CITY OF BOULDER
PLANNING BOARD AGENDA ITEM
MEETING DATE: October 6, 2016

Public hearing and actions on the following items related to development review applications for properties located at 4801, 4855, 4865 and 4885 Riverbend Road within the Riverbend Office Park:

Project Name: Boulder Community Health (BCH) Riverbend Medical Pavilion and Parking Garage

L1.0

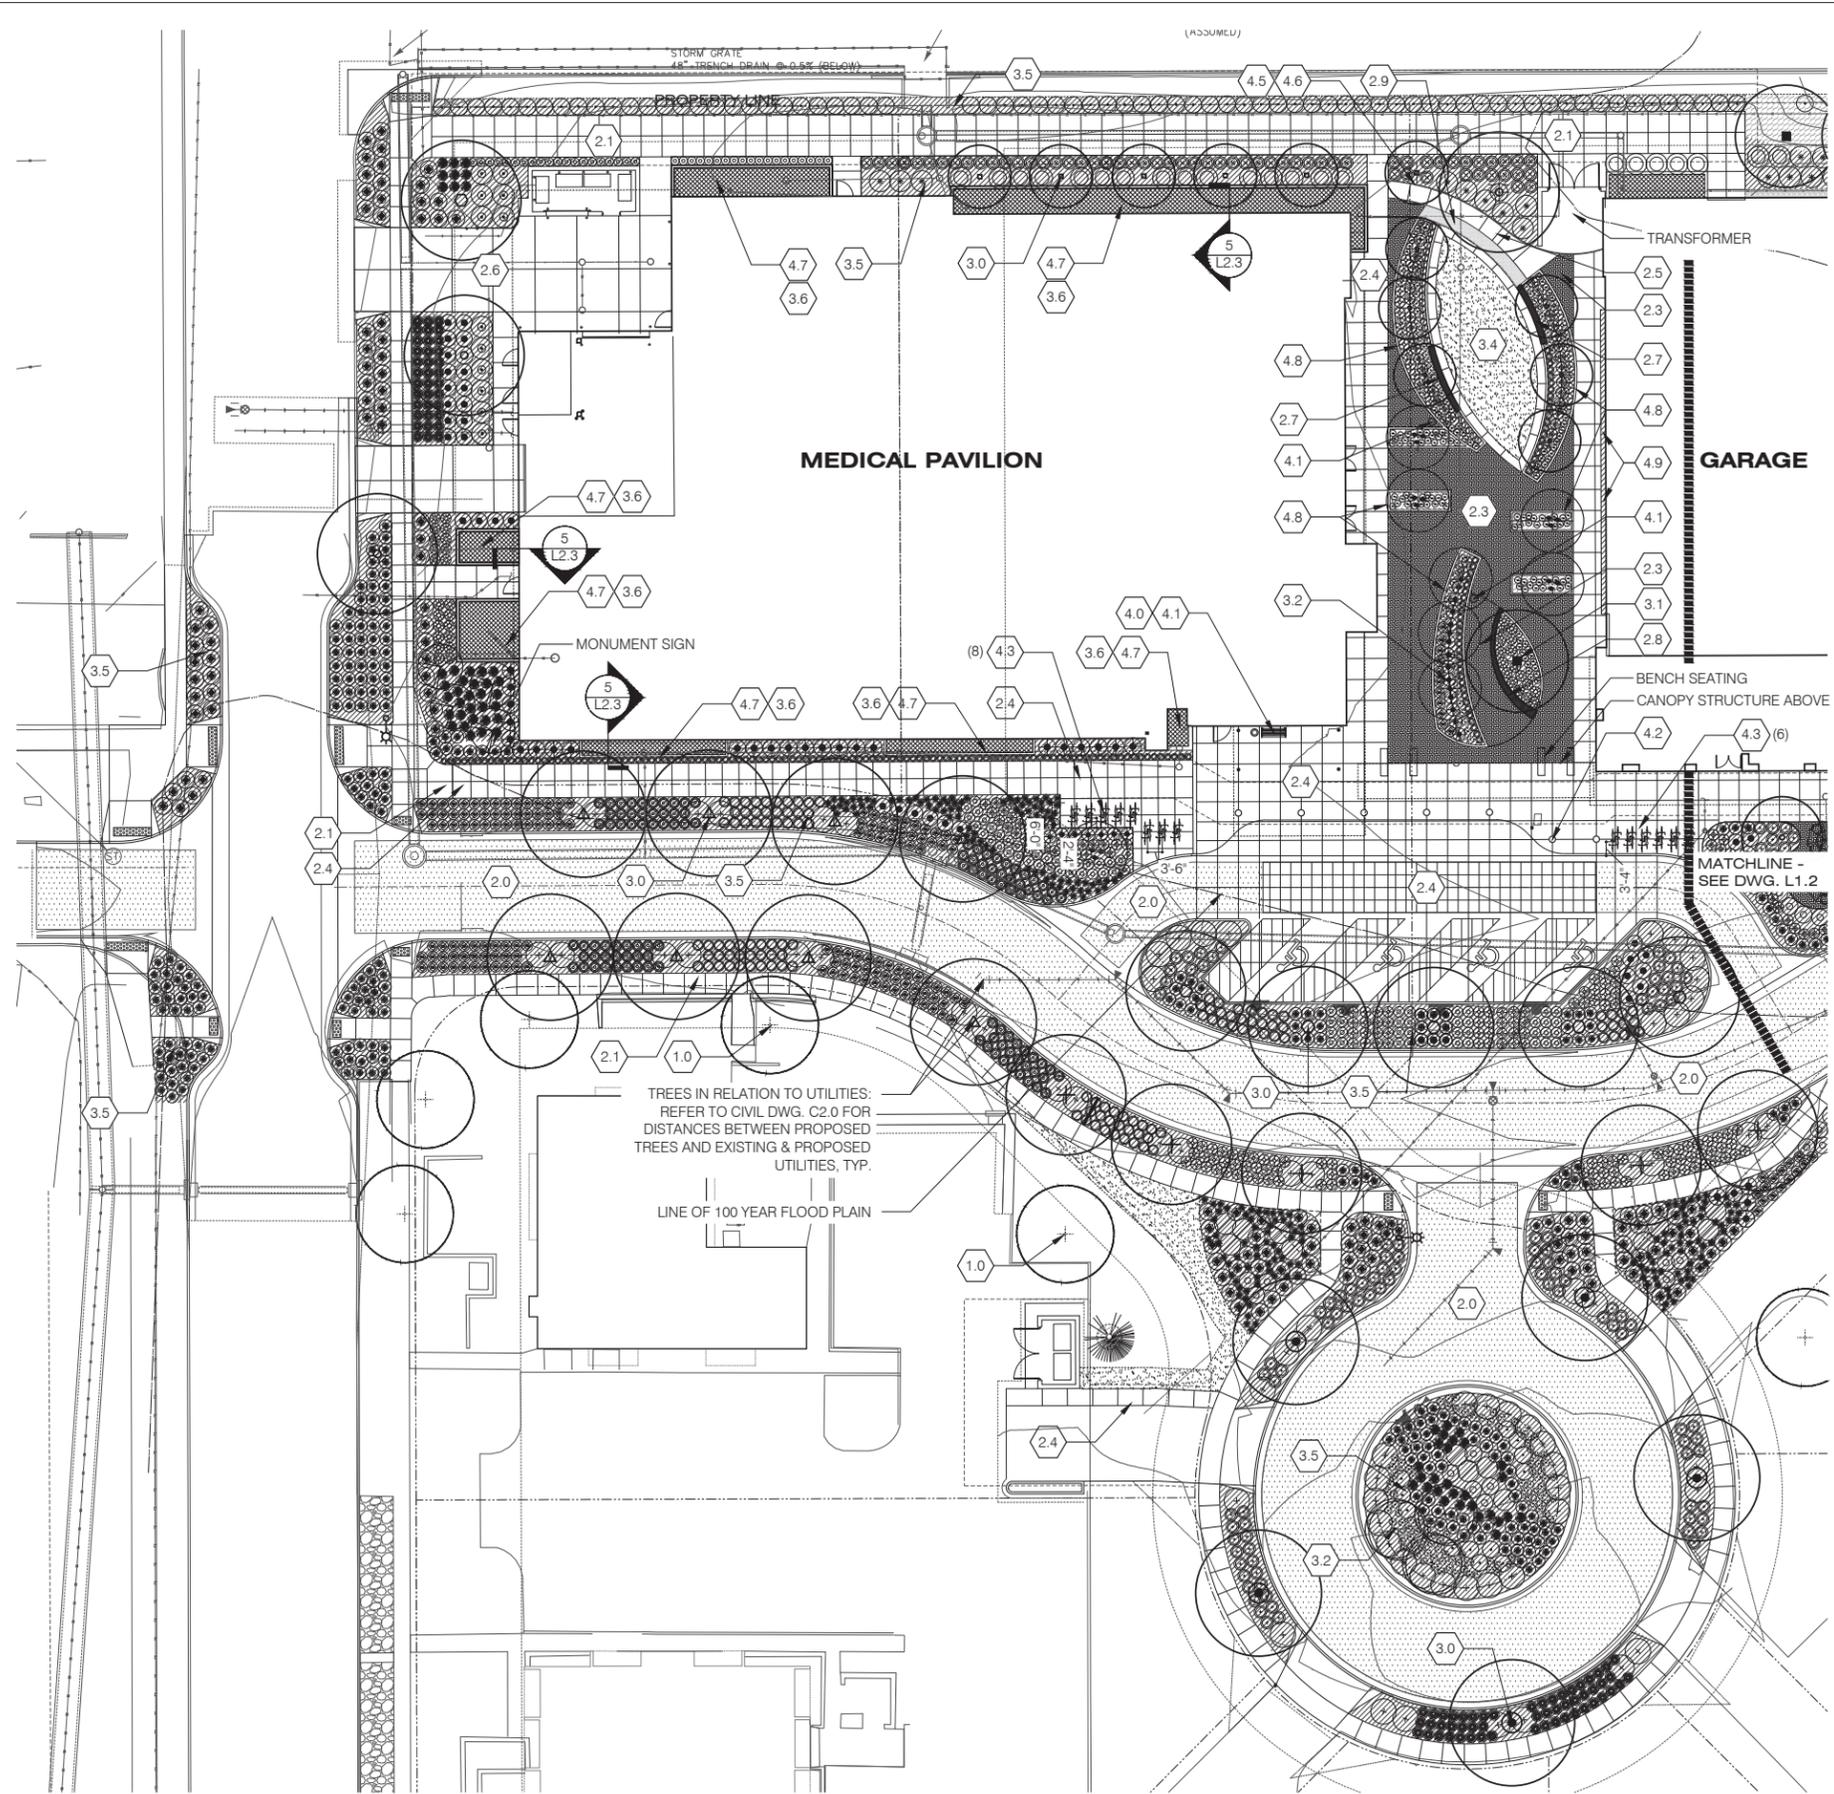
11. Please update the Summary Chart of sheet L1.0 to reflect actual street frontage and required and provided quantities for street trees.

5 RAIN GARDEN - TYPICAL SECTION DETAIL
SCALE: 3/8" = 1'-0"

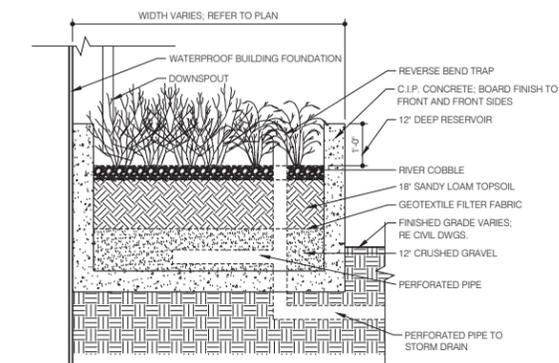
10. The rain gardens have been successfully integrated in similar building contexts; however, the planting palette included on sheet L2.3 includes primarily full sun perennials and the majority of the rain gardens are part sun or full shade. Evaluate a wider range of plant options to accommodate the exposure. Fully detailed planting design is not needed until Technical Document if changes are anticipated, but the plant palette would be very helpful to develop now. Detail 5 on the same sheet also calls out 3" of mineral mulch while the material keynotes call out cobble. Please coordinate. Three inches is probably not necessary. The minimum amount of mulch necessary to help control moisture loss and weeds should be specified.

SITE FURNISHINGS

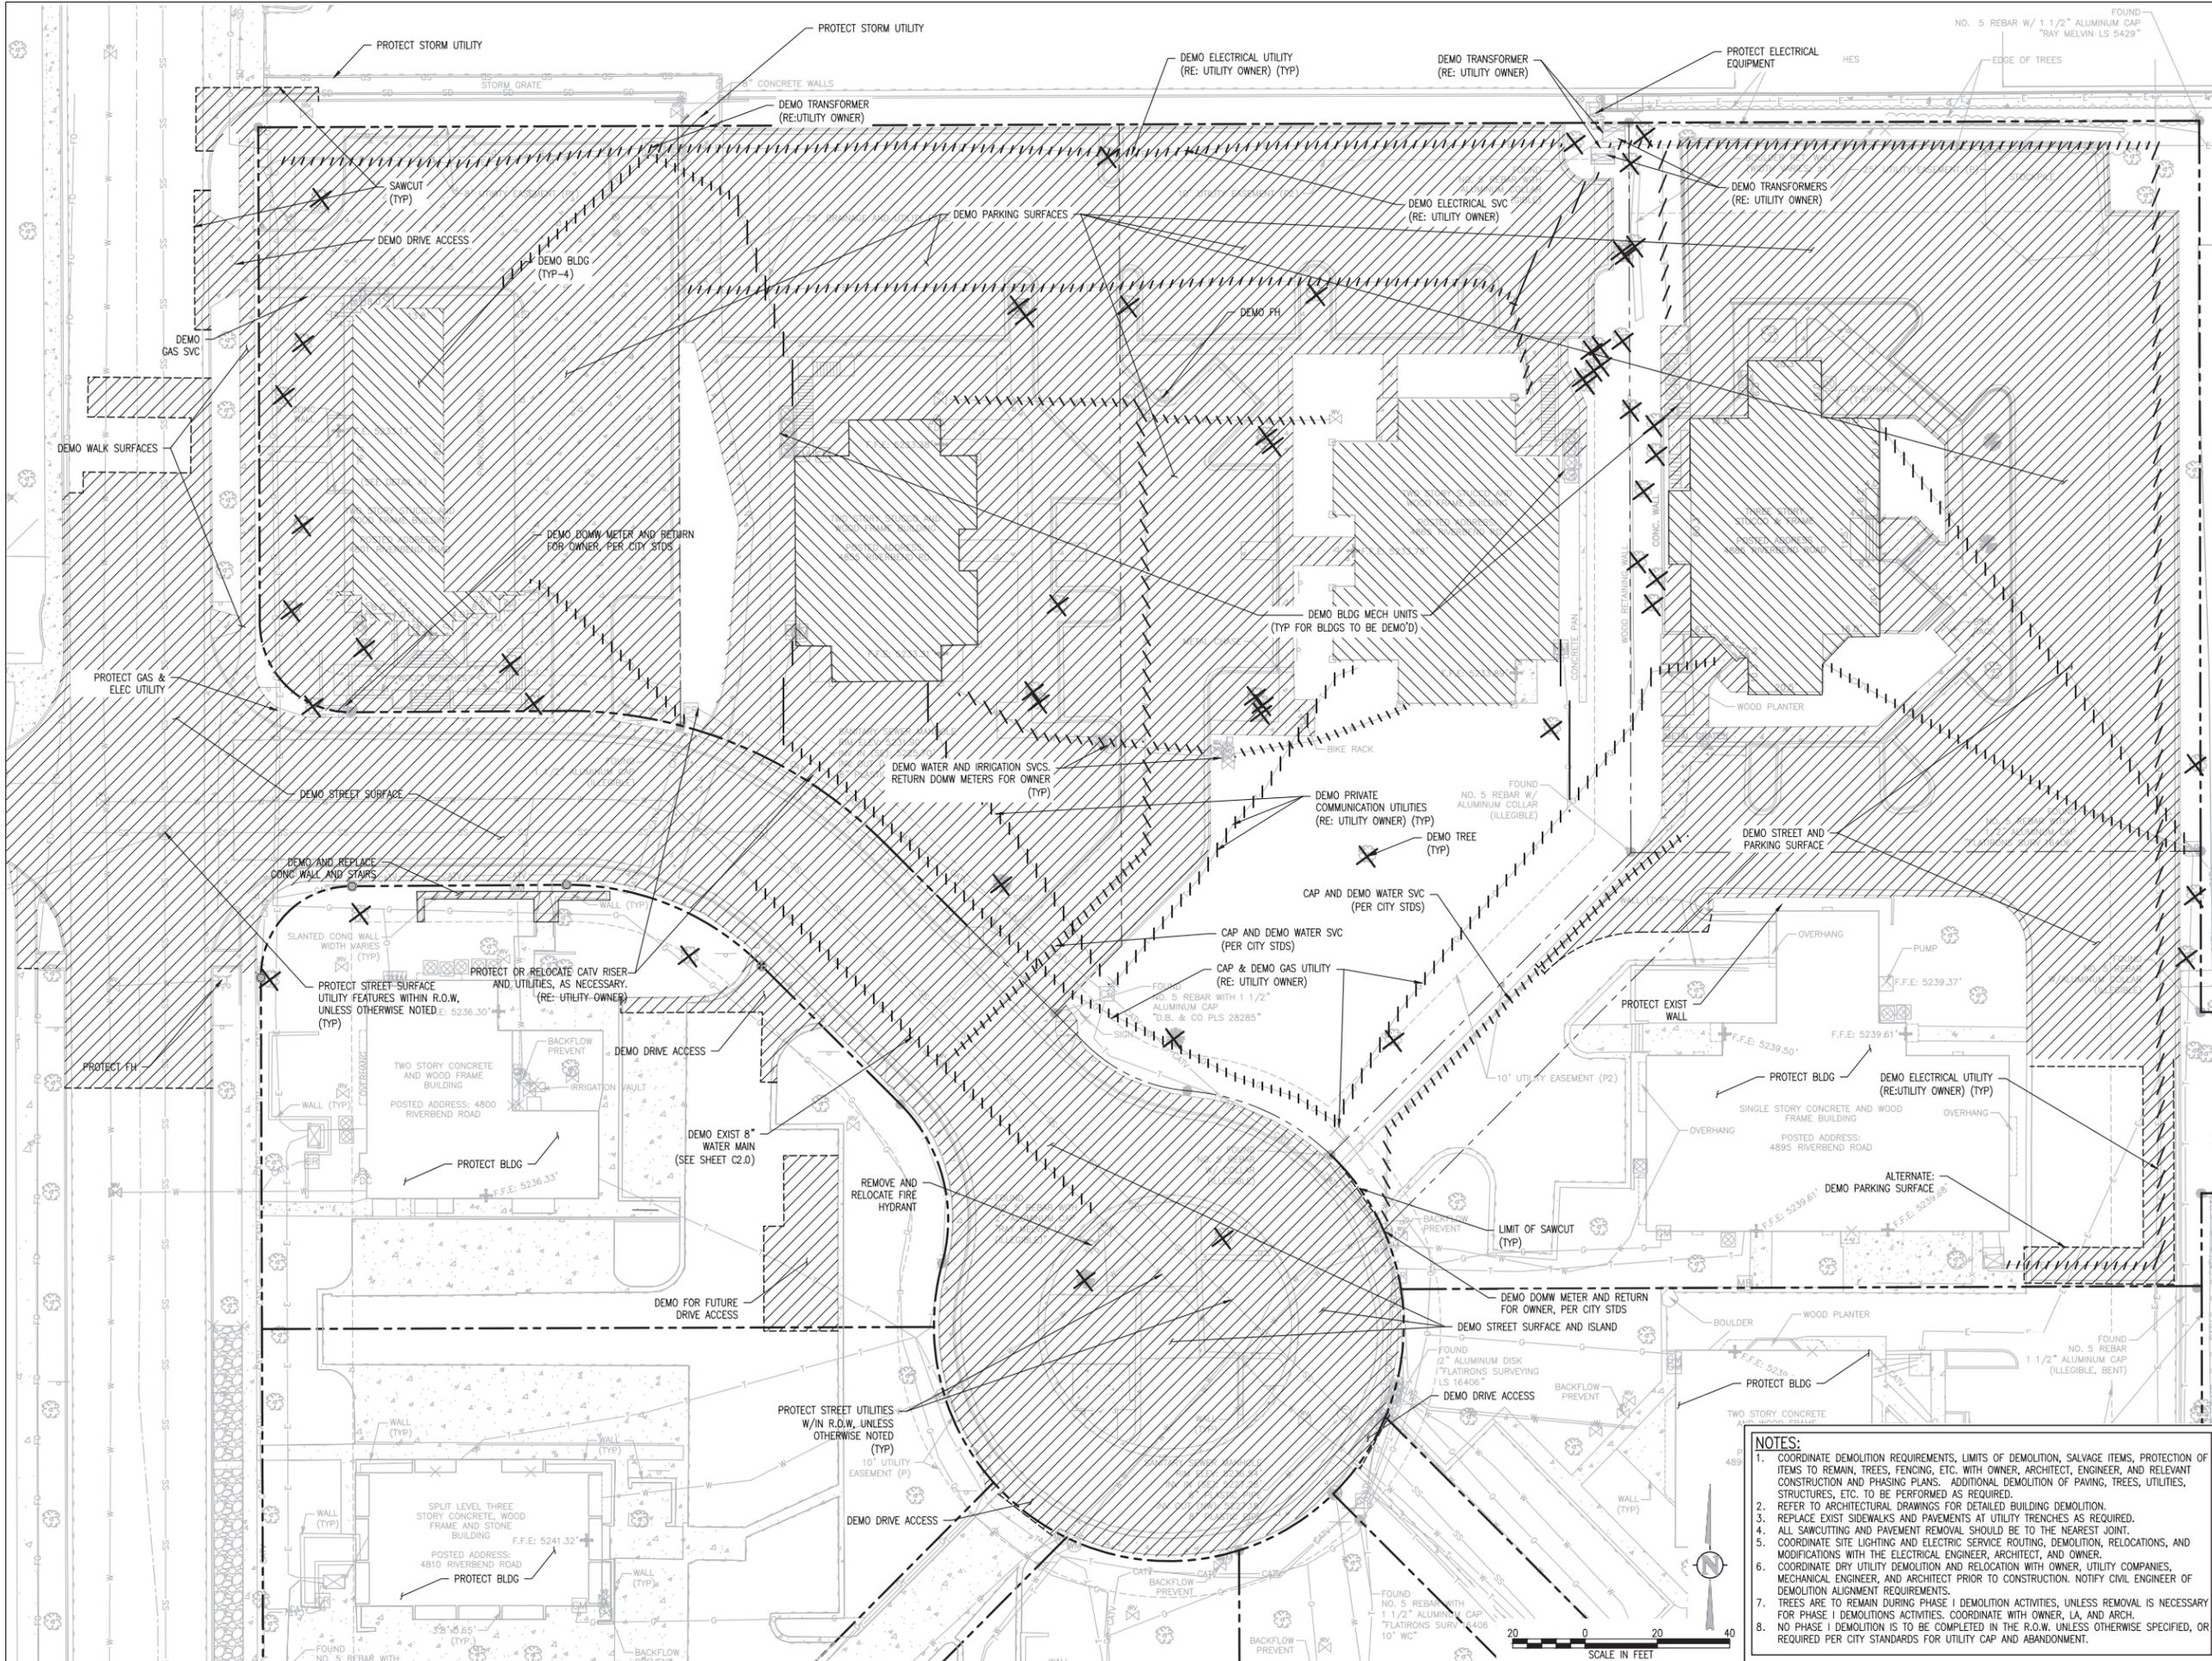
2. Please use the city approved U-rack detail on sheet L3.0 available from the Design and Construction Standards.
3. Please note that additional species selection comments may be provided at the Technical Document Review.

C5.0

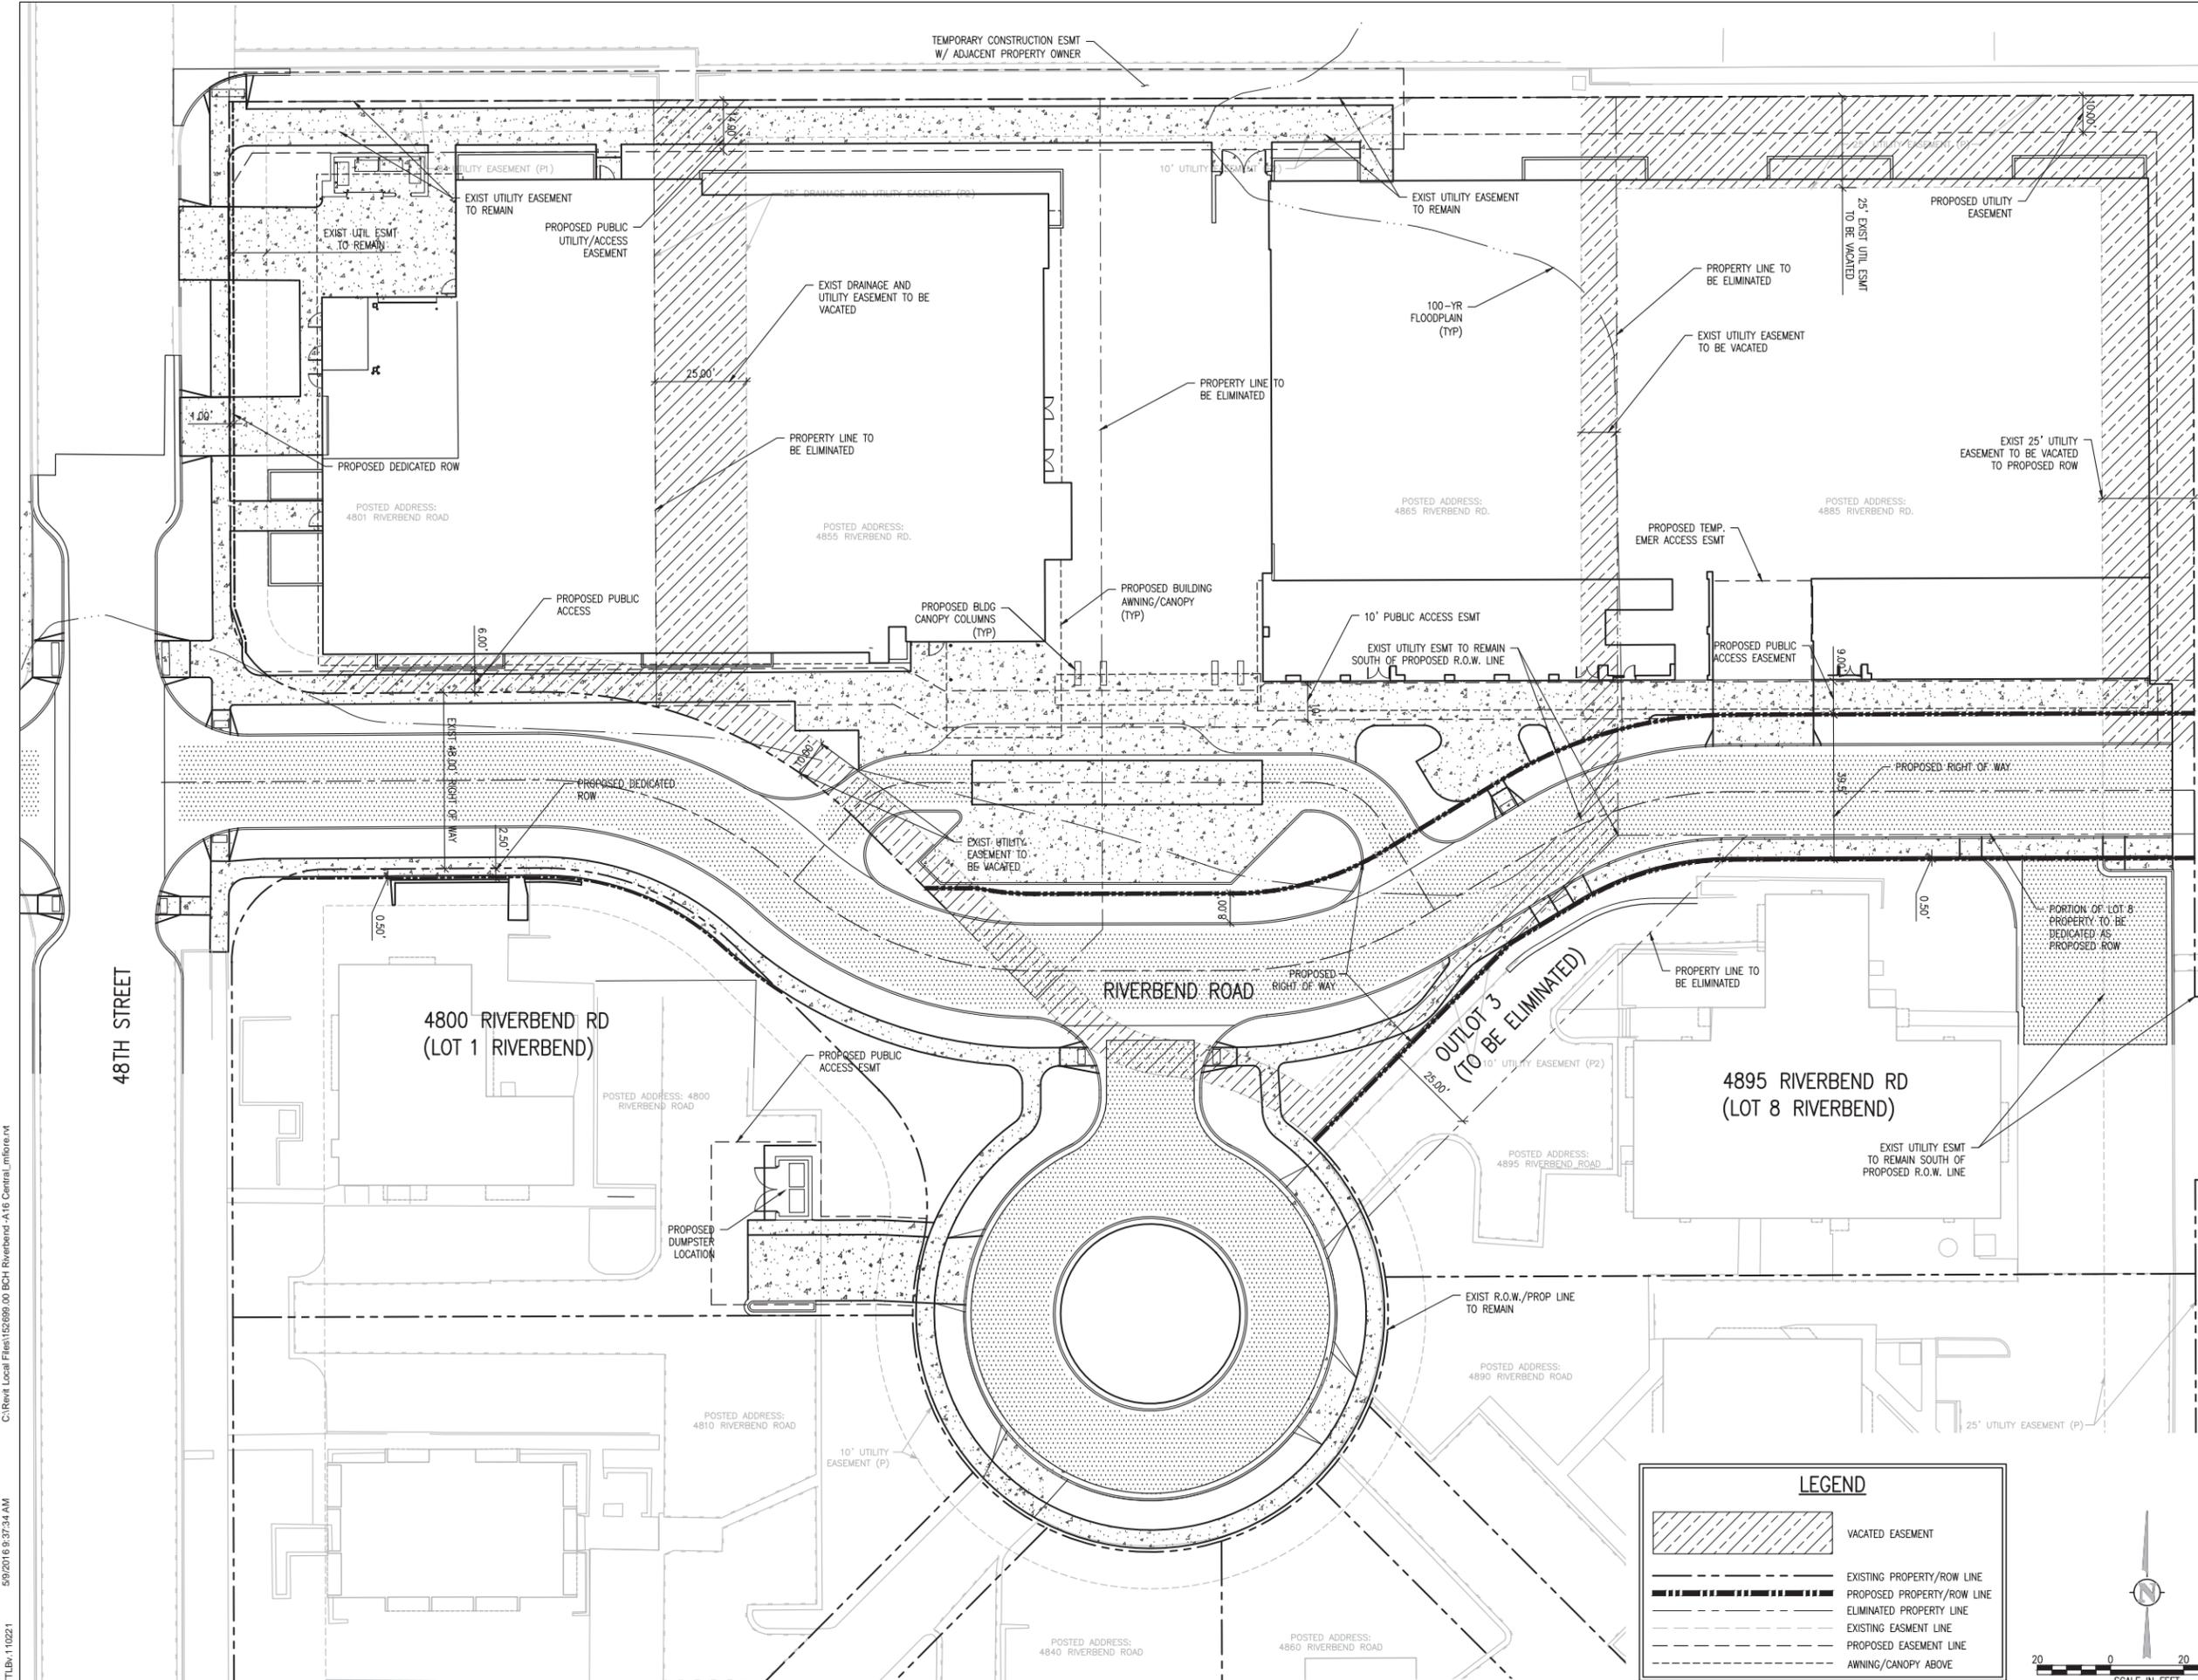
1. Without a preliminary plat it continues to be confusing the limits of the public right-of-way to be dedicated on the site. Staff finds that the engineering sets should be updated to clarify that a portion of the right-of-way limits by the northeast quadrant of the round-a-bout should be shown to be eliminated as the right-of-way will continue onto the new portions of Riverbend Road. This can be done on Sheet C5.0.
